STATE OF NORTH CAROLINA
DEPARTMENT OF TRANSPORTATION

June 11, 2015

RE: Addendum to the Section 404 Individual Permit 10 & Section 401 Water Quality Certification for the replacement of Bridges No. 12, 18 & 42 on NC 11 Over Cape Fear River and Overflow; Federal Aid Project No. BRSTP-0011(9) W.B.S. No. 33395.2.2 T.I.P. Project No. B-4028

Revised 6/9/2015
 Permit Drawing
 Sheet 15 of 19

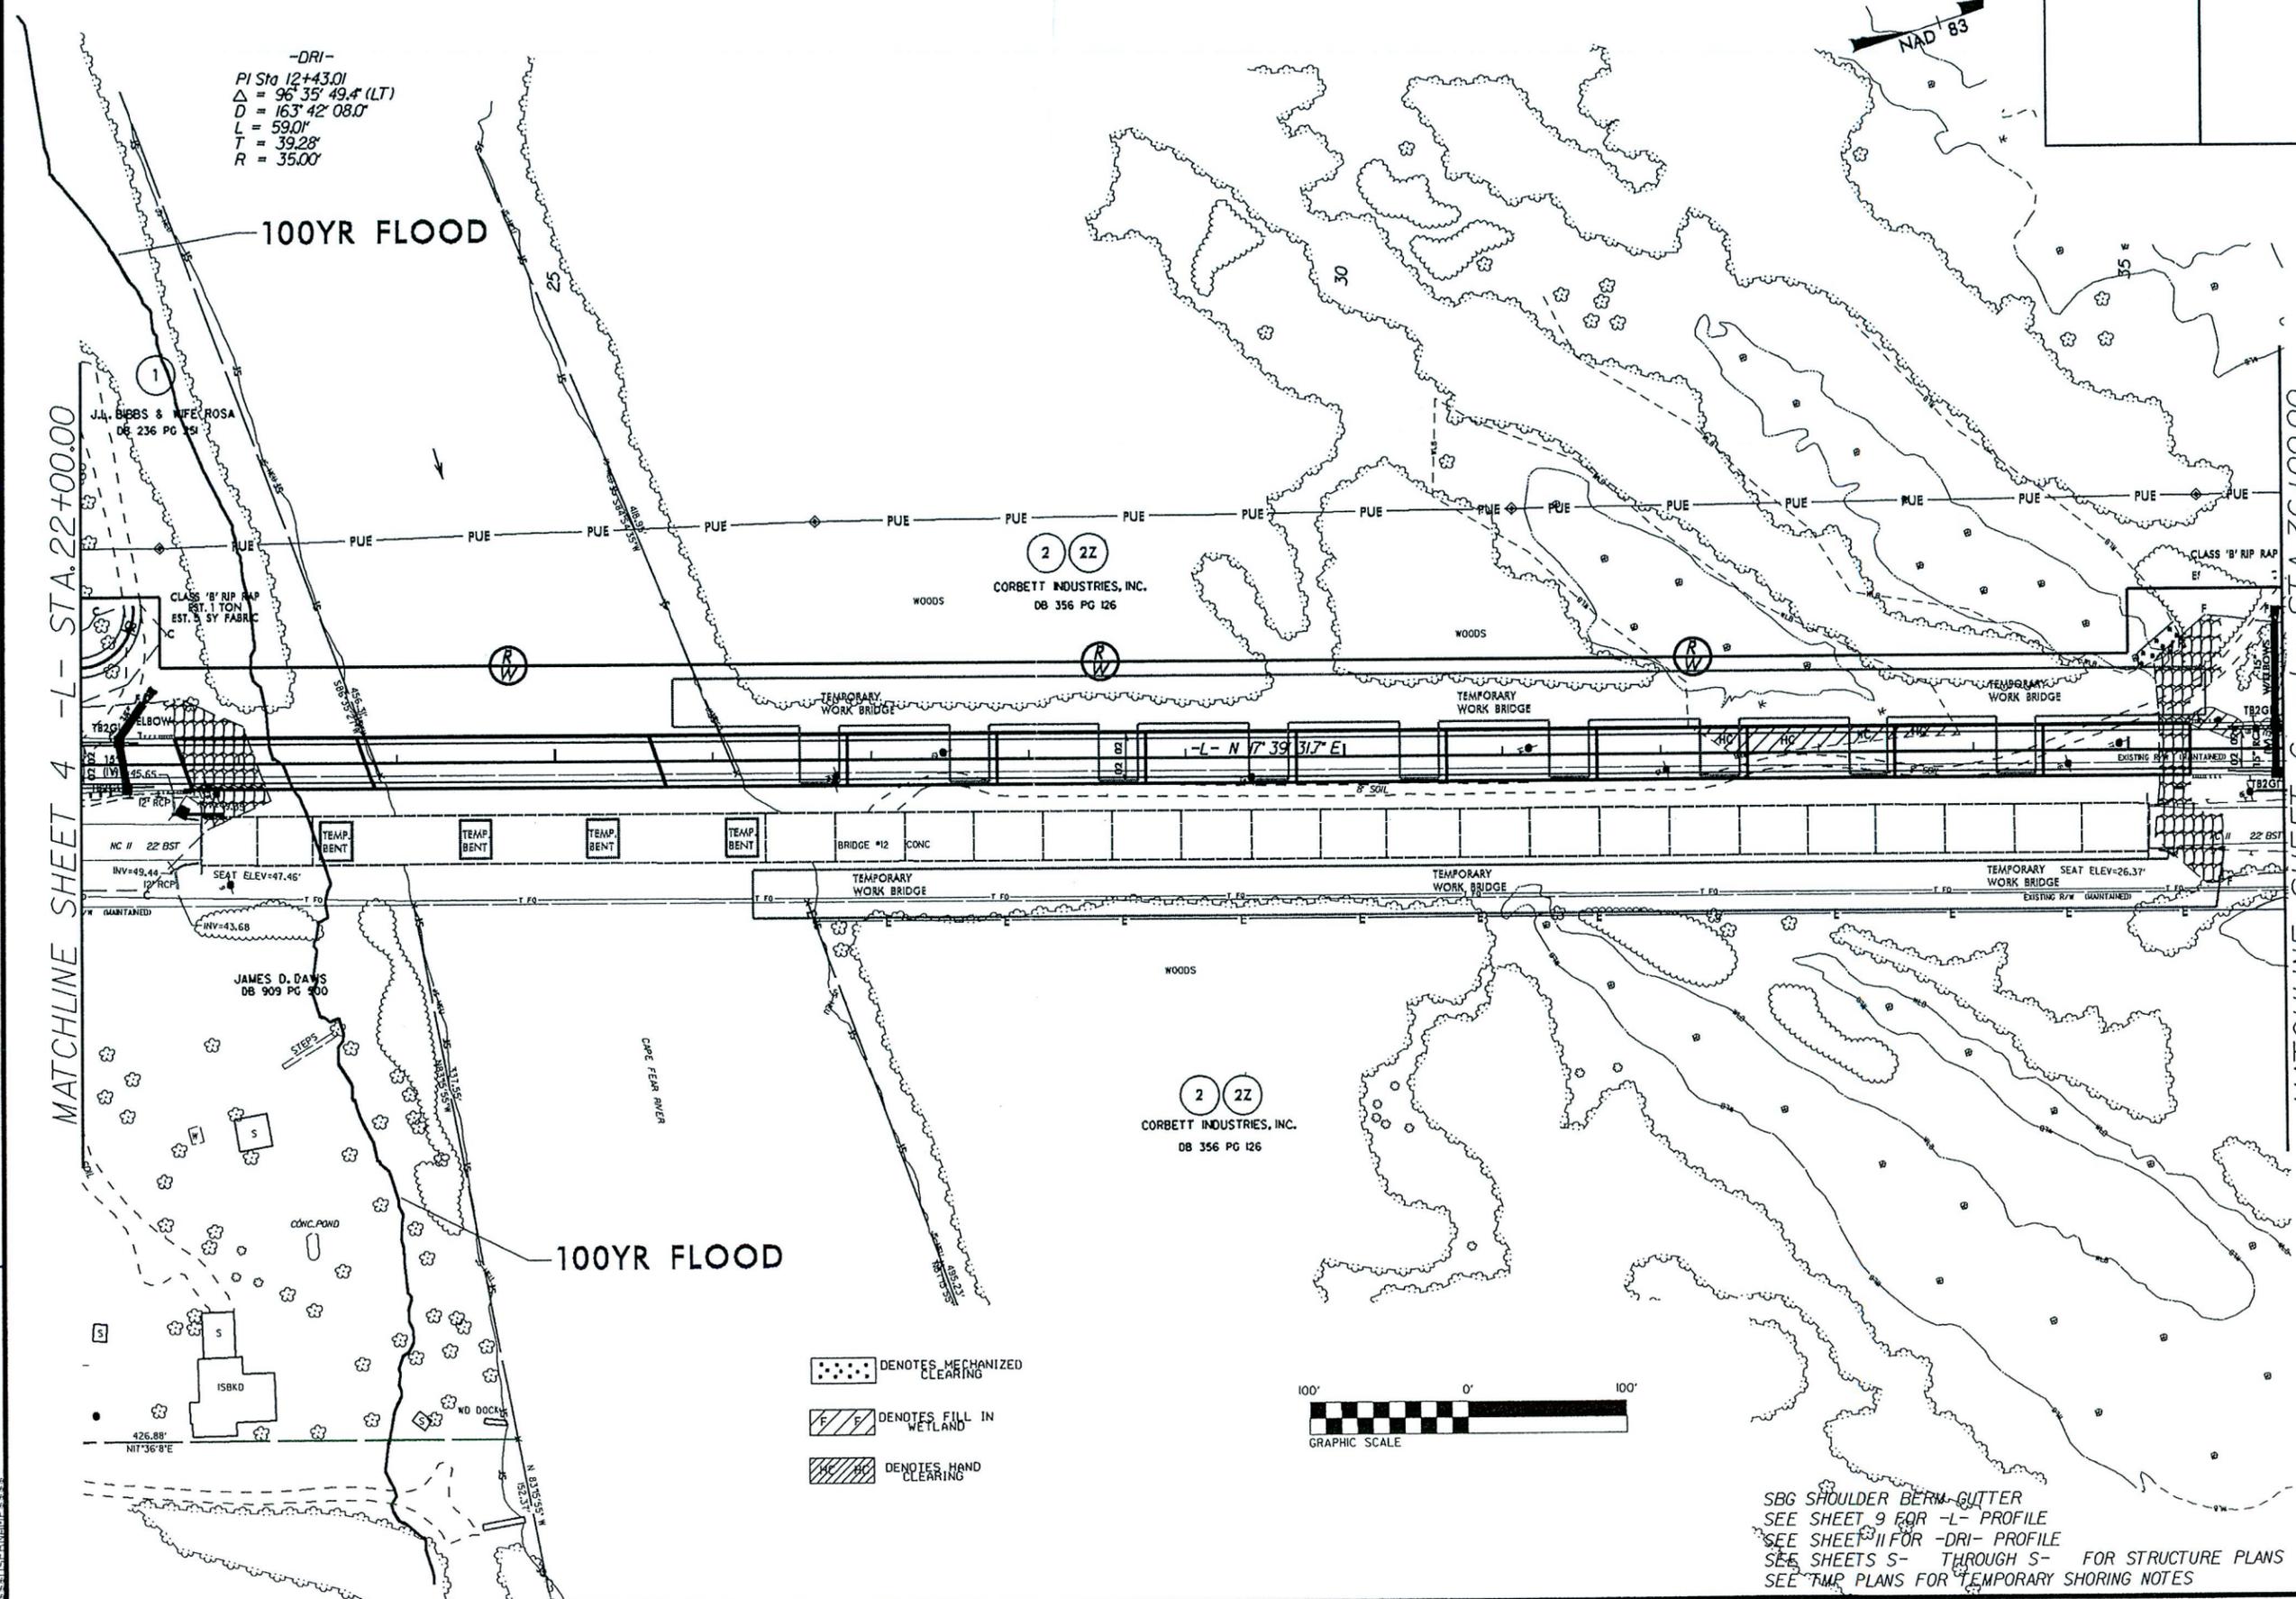
Please see the enclosed revised plan and profile view for the subject project. A discrepancy between the permit commitments and the construction plans necessitated clarification. The permit application stated that the existing causeway would be removed and the area graded down to natural ground elevation within the easement (pg. 7 of cover letter), however the Roadway plans submitted with the application (Cross section X-22) shows only partial removal. After confirmation with the contractor, the Department plans to grade the area in accordance with the Roadway plans.
